FORM P3: ADMINISTRATIVE DECISIONS AND MINOR AMENDMENTS

RE: **Administrative Amendment**
Locker Room at Mesa del Sol
BP-2021 – 53855
Letter of Justification

ADMINISTRATIVE AMENDMENT •
OVERALL SITE PLAN
LOCKER ROOM FACILITY AT MDS

Re: Revised NM United Locker Room Facility on University Blvd., SE
Mesa del Sol Architectural Review Committee (ARC) March 1, 2022 Comments

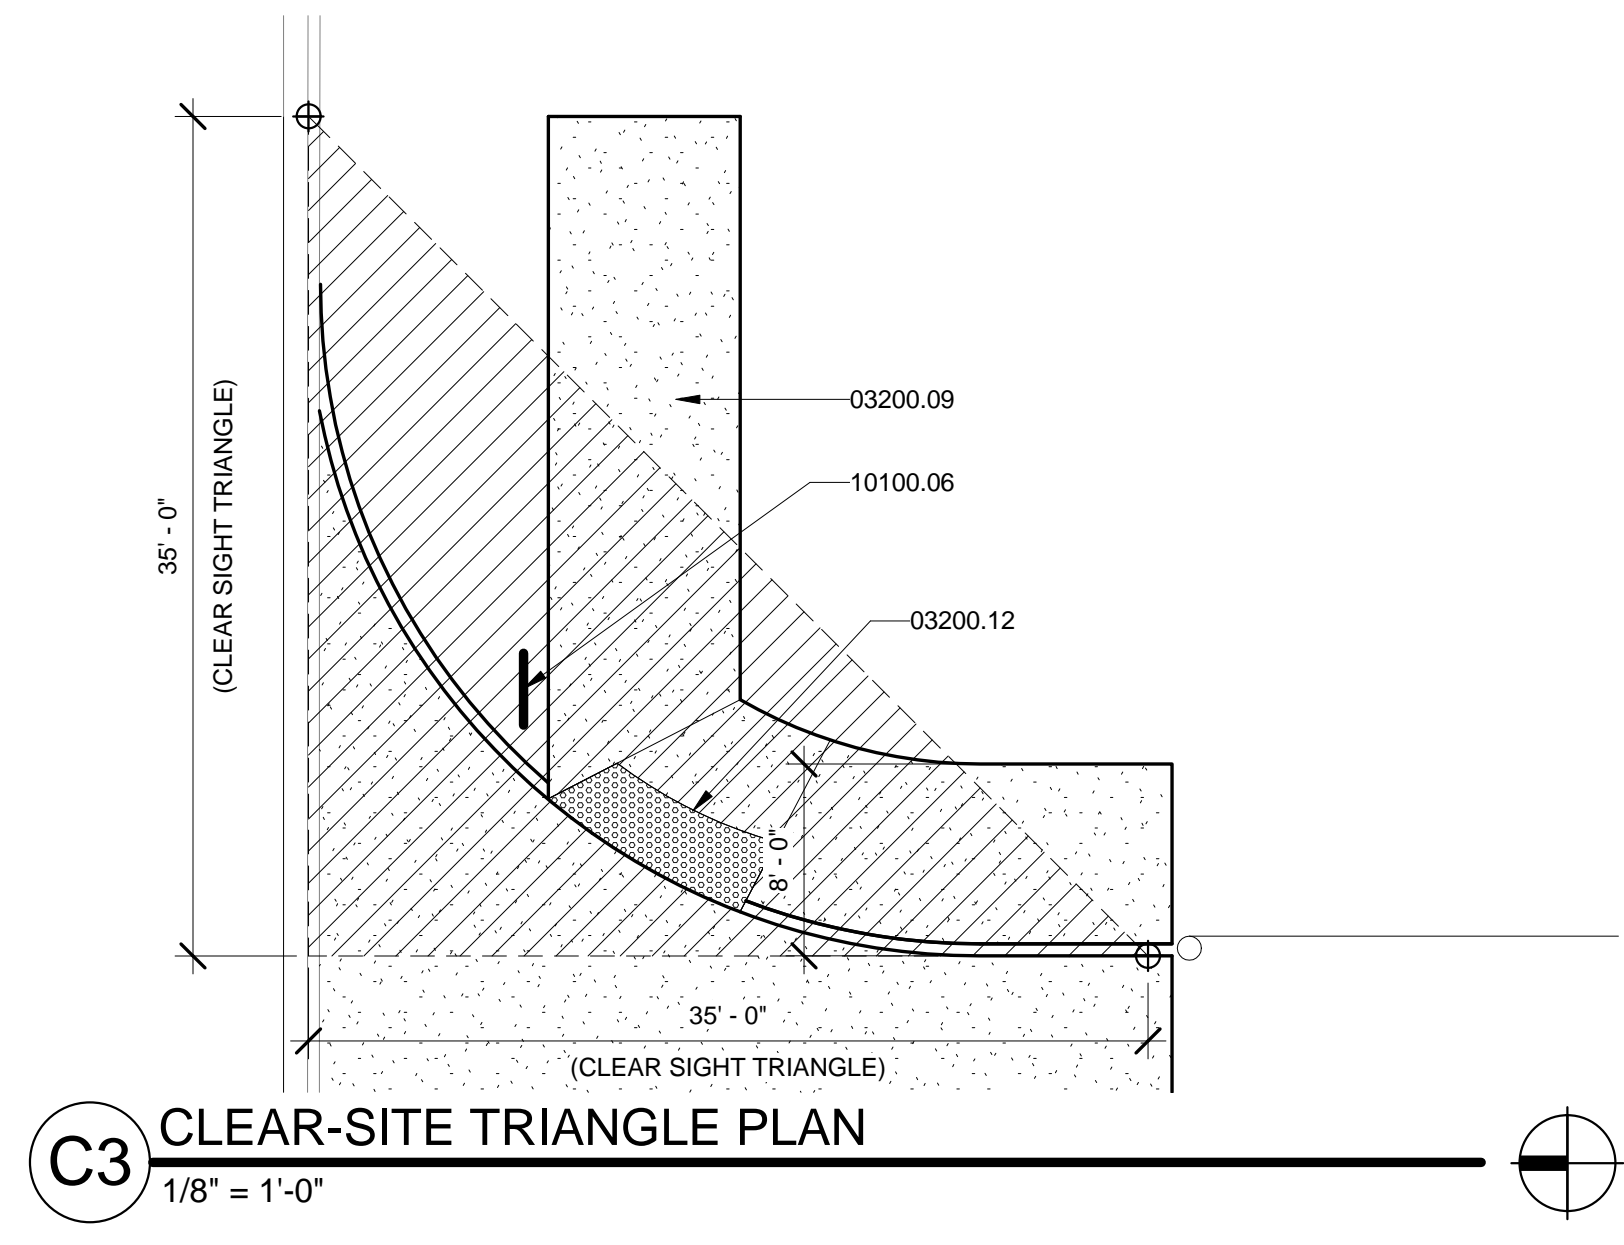
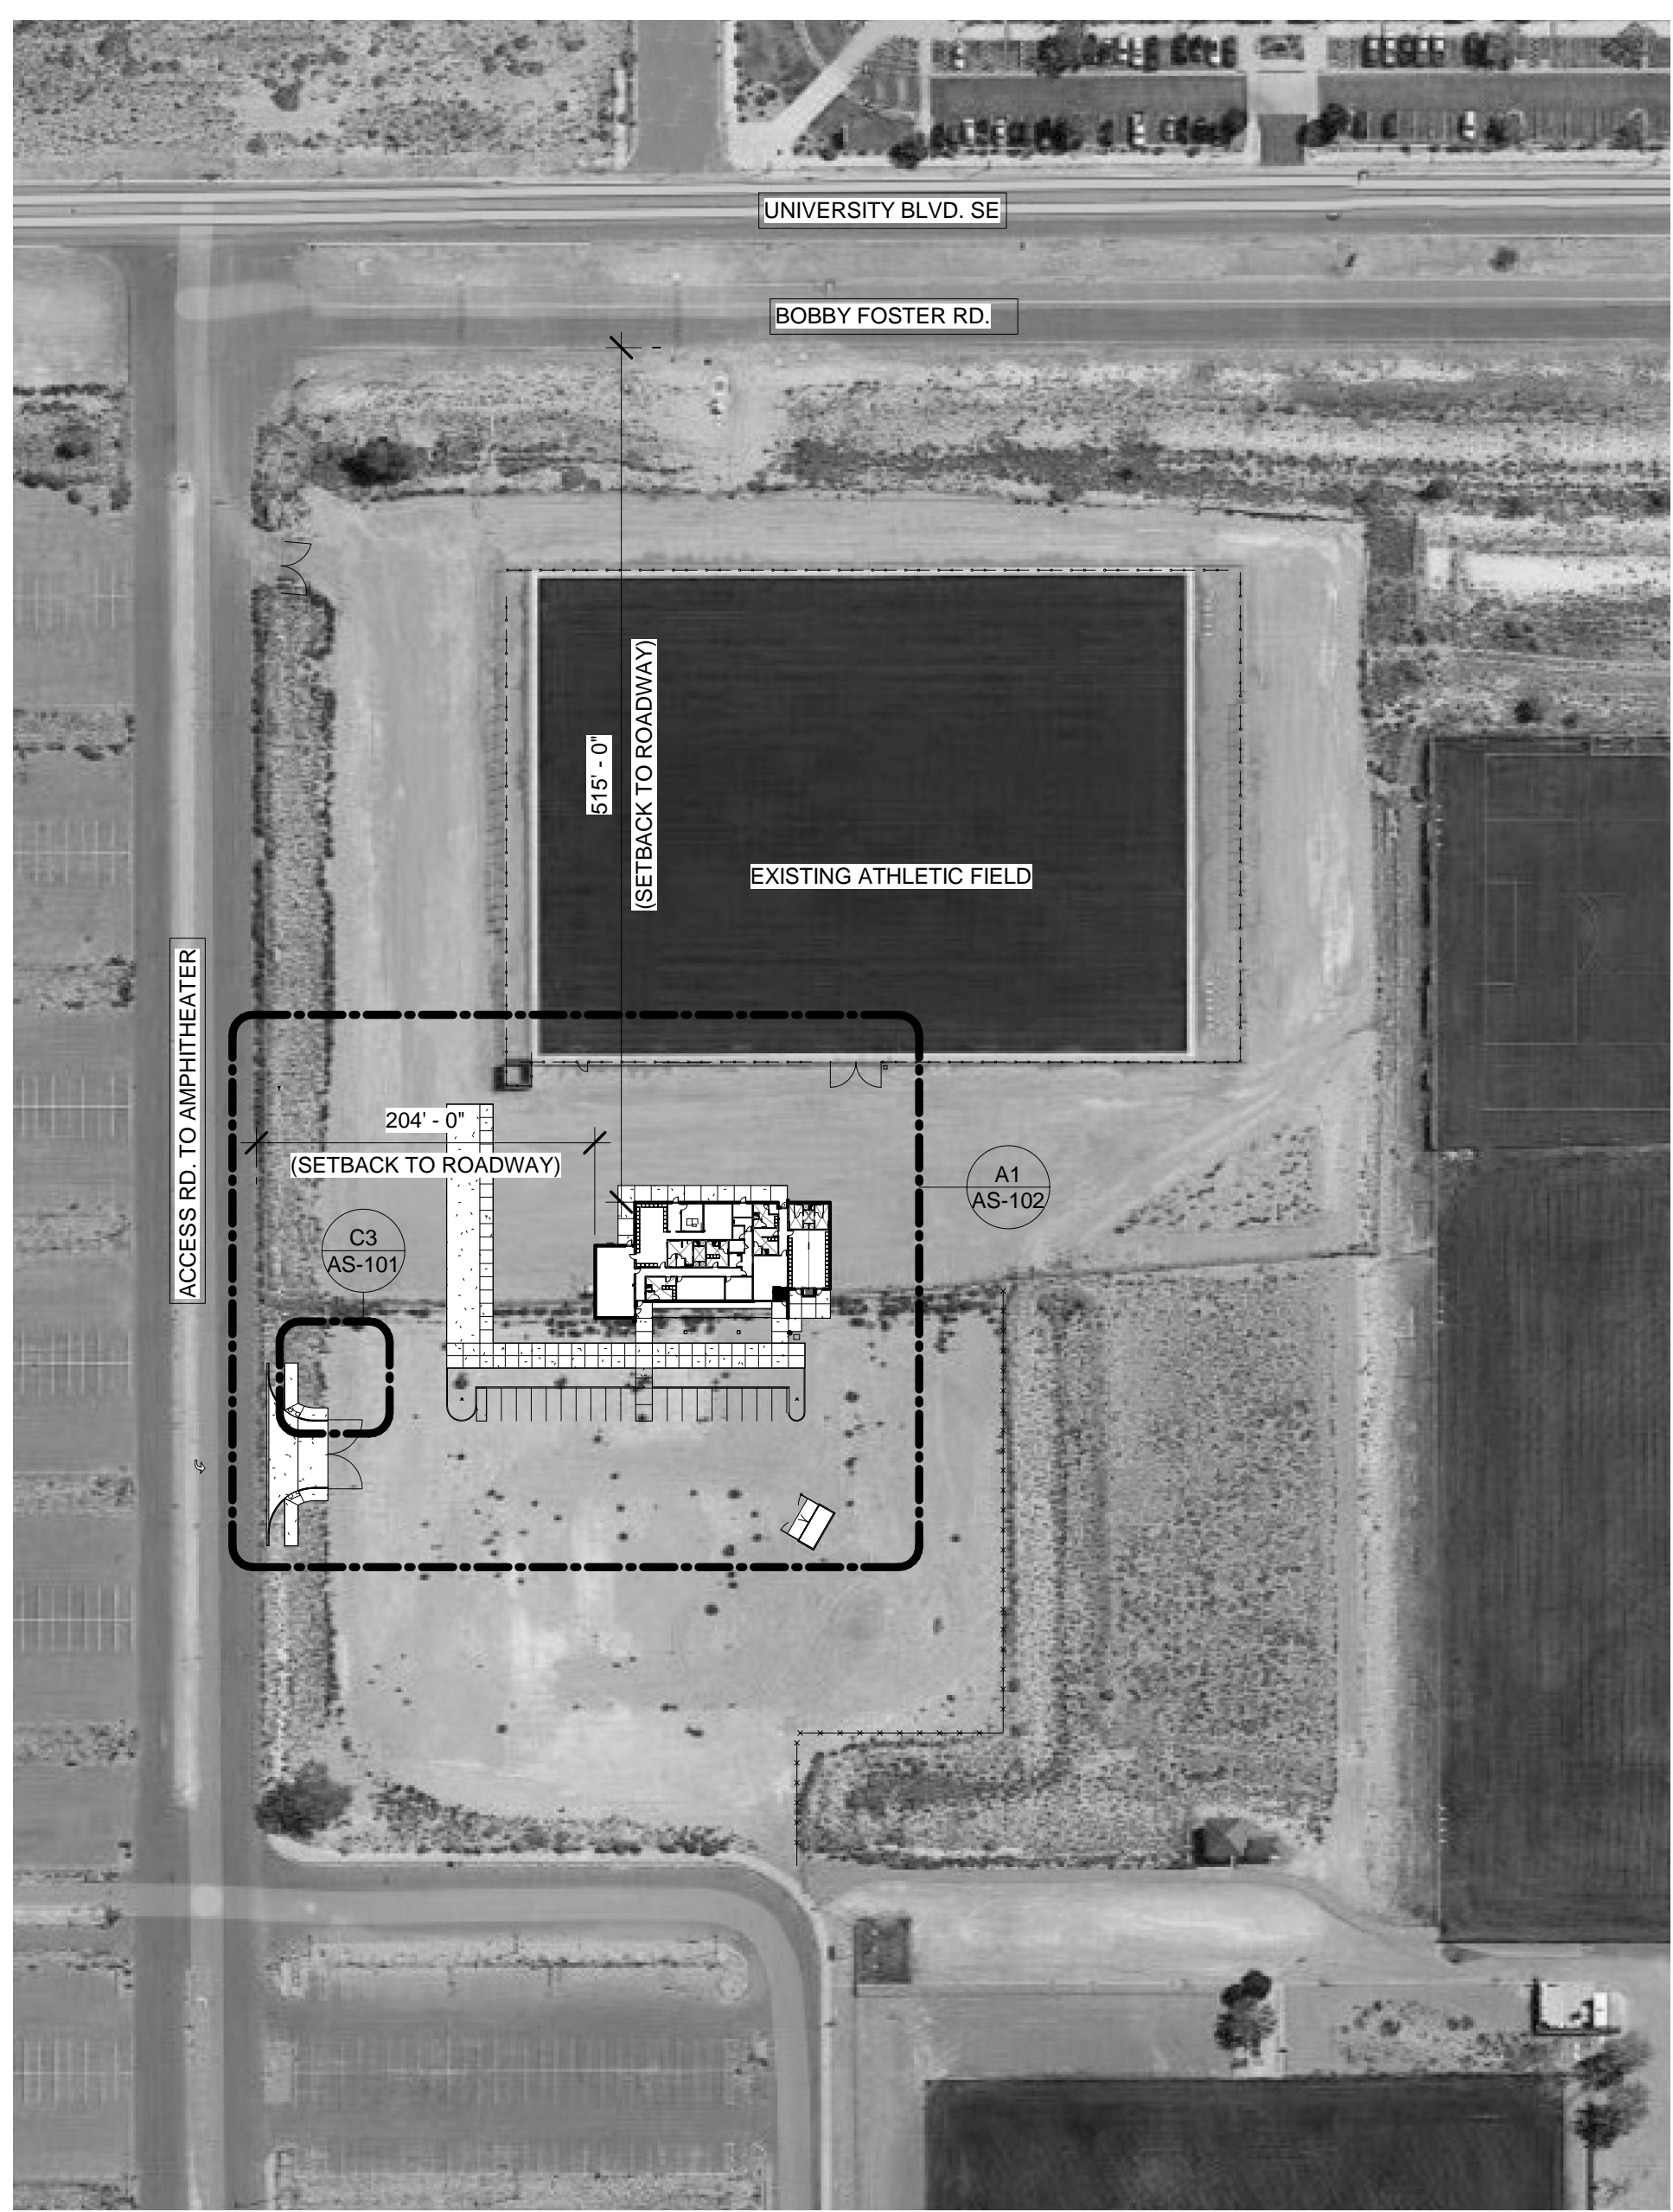
**PREVIOUSLY APPROVED SITE PLAN • MODIFIED
PER THIS ADMINISTRATIVE AMENDMENT •
LOCKER ROOM FACILITY AT MDS**

**ADMINISTRATIVE AMENDMENT • SITE PLAN
LOCKER ROOM FACILITY AT MDS**

A1 SITE PLAN-AA
1" = 20'-0"

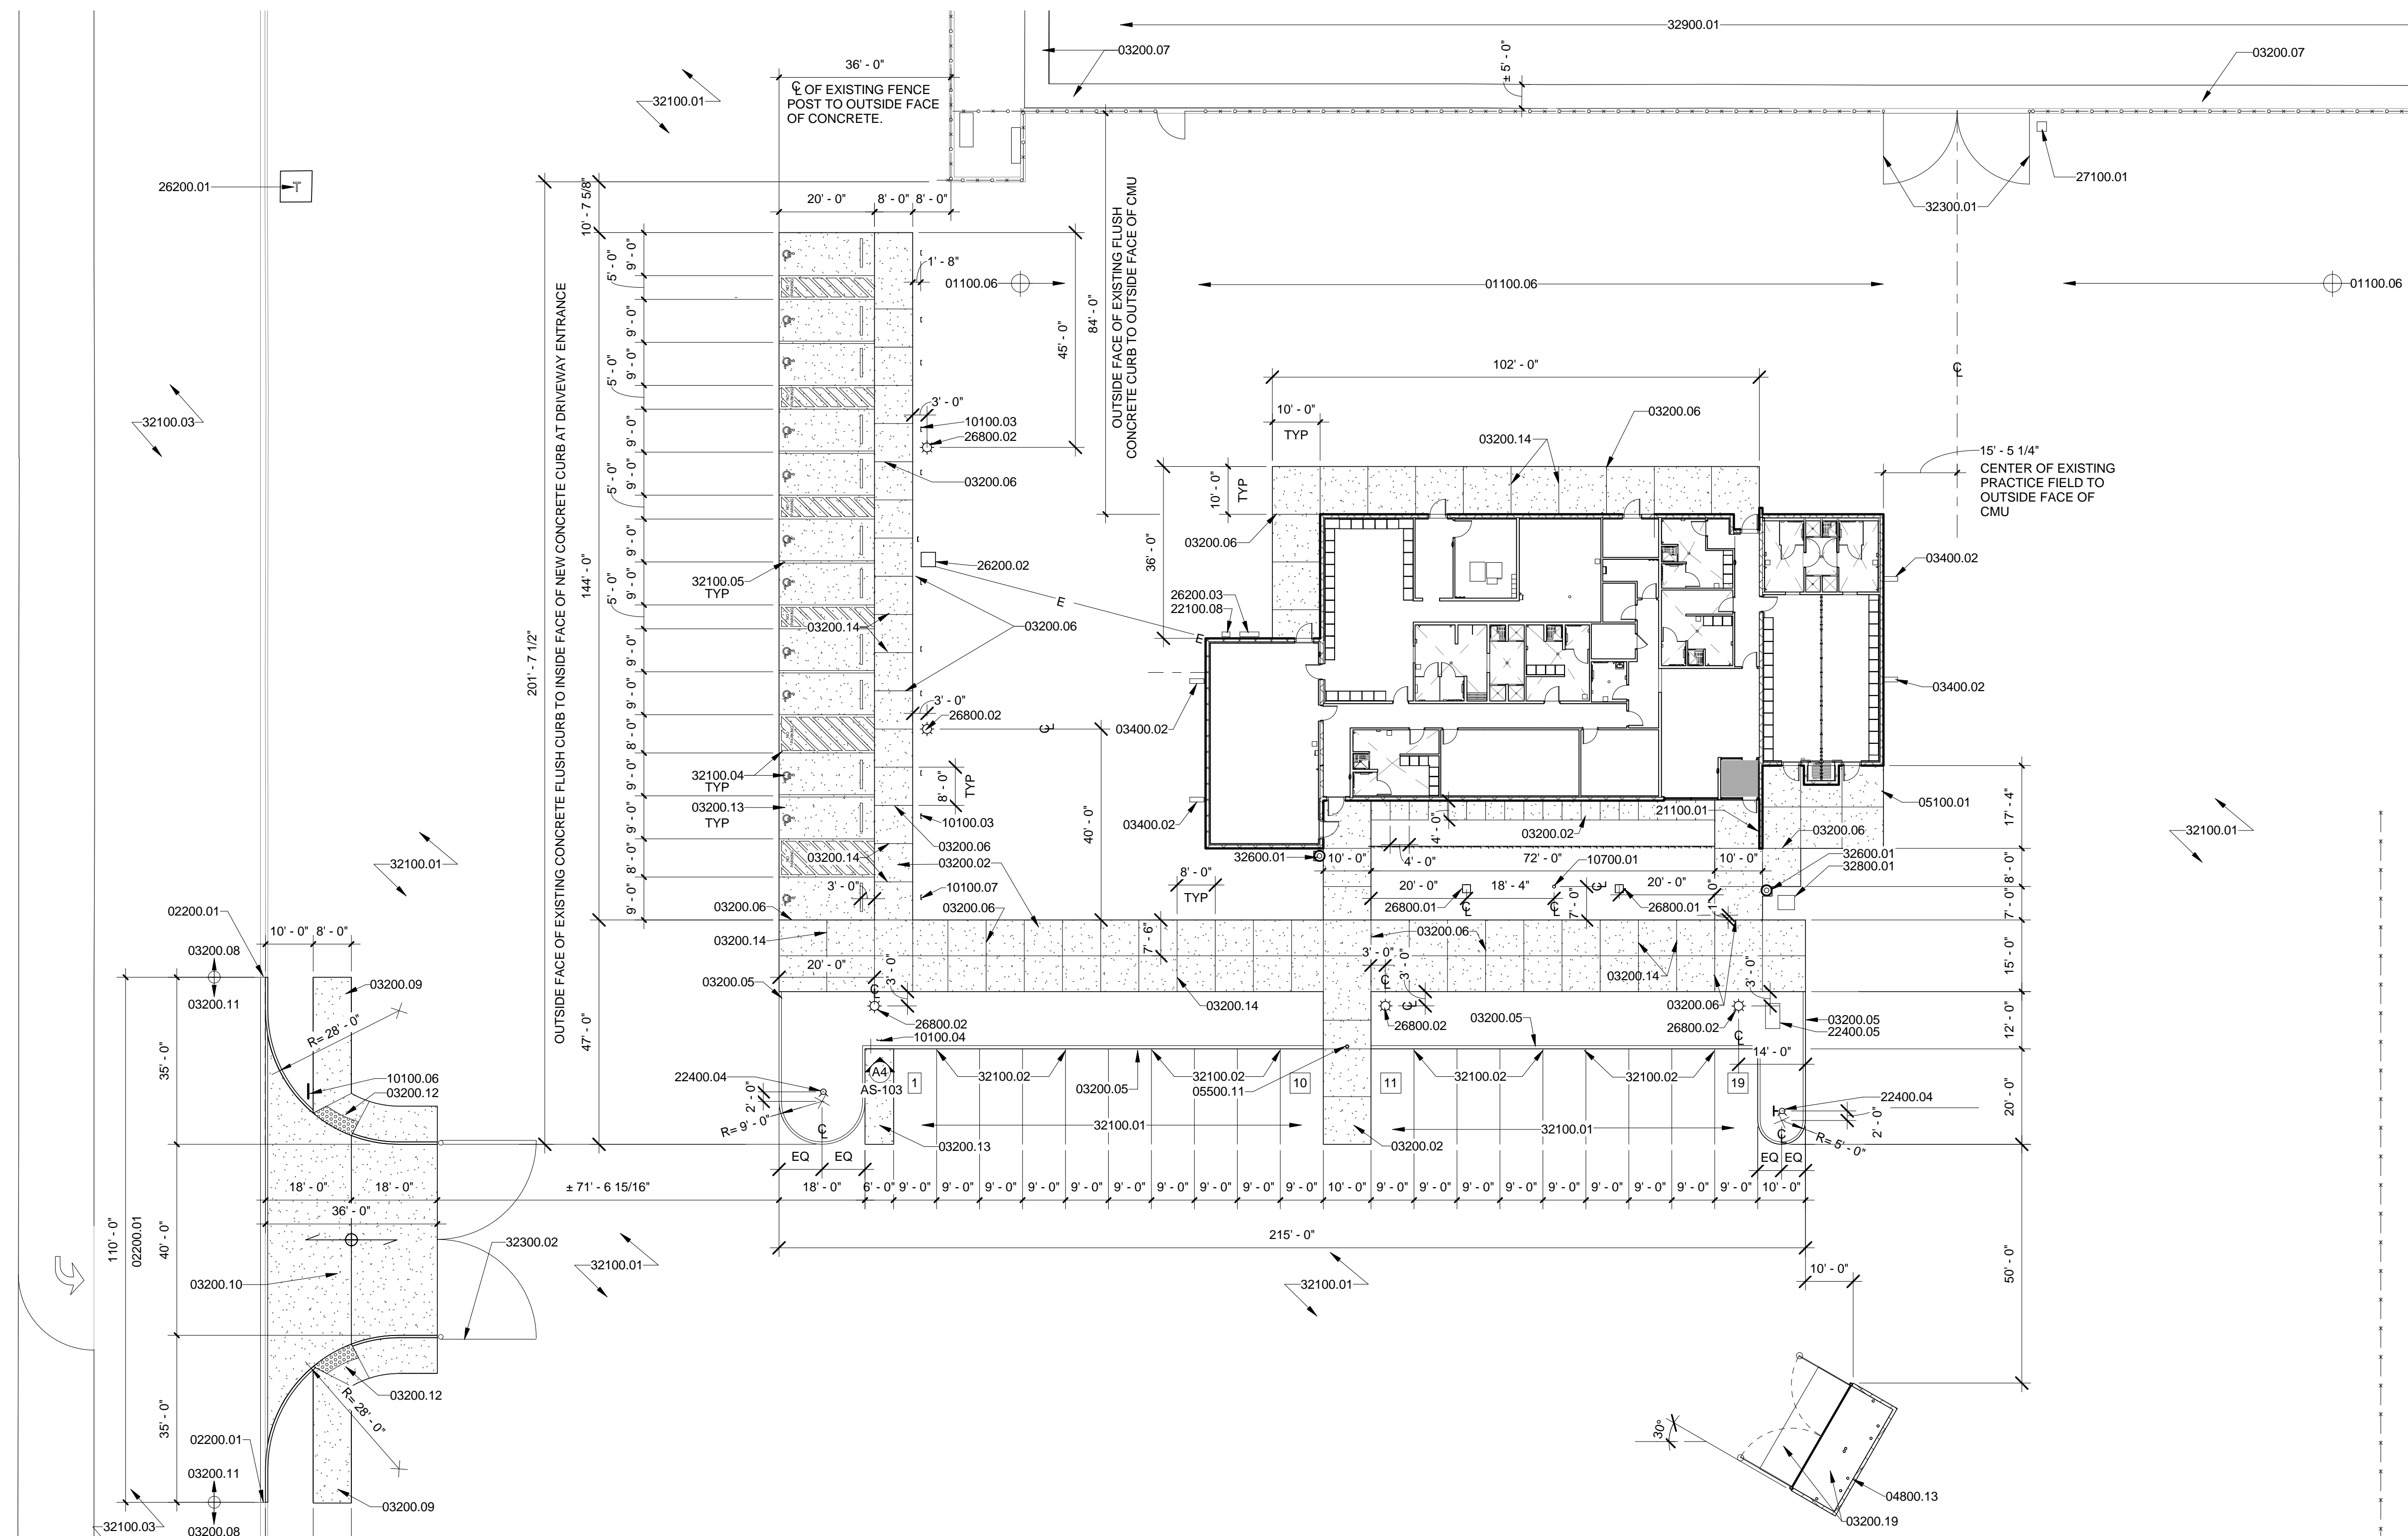
2. The ARC requires that the trash enclosure be moved from the (very visible) location on the Northwest corner of the site to the (less visible) Southwest corner of the site.

3. The light poles in the parking lot and on or near the building must comply with the height requirements of the Recreational Complex master plan, as well as the Night Sky Ordinance, and such additional requirements (if any) imposed by Kirtland AFB (KAFB) or the Department of Energy (DOE).

- A. EXTERIOR LIGHTS AND LIGHT POLES SHALL BE INSTALLED NO TALLER THAN 18' ABOVE GRADE. LIGHT FIXTURES SHALL COMPLY WITH THE NIGHT SKY ORDINANCE, AND SHALL COMPLY WITH THE REQUESTS OF KIRTLAND AFB AND/OR THE DEPARTMENT ON ENERGY.
